Access Compliance Report Public Rights-of-Way (Curb Ramps)

Main Street: DORRANCE_DR		Cross Street: O_NEILL_DR		Location:	NW
ADA ID: RPRK211026132949	Ramp Type: Type 1 - Perpendicular	Initial Pass/Fail: Fail	Overall Compliance: No	Severity Score:	16
Codes/Mitigation Info/Possible Solution			Field Measurements/Component Compliance

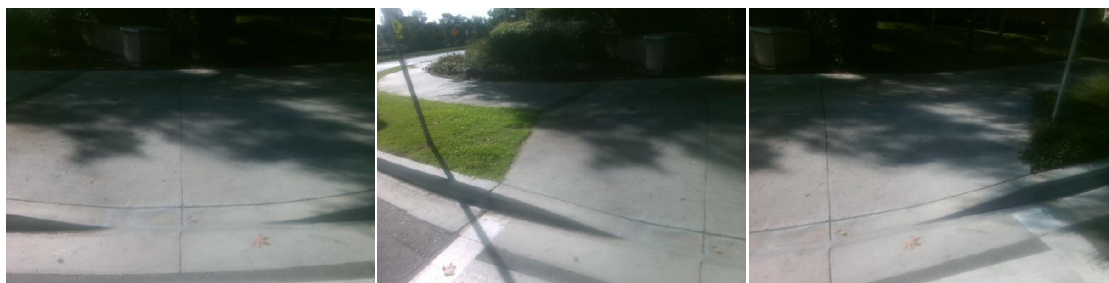
R304.2.2, R204.3, R304.5.3, STD 1115

Remove & Replace Entire Ramp.
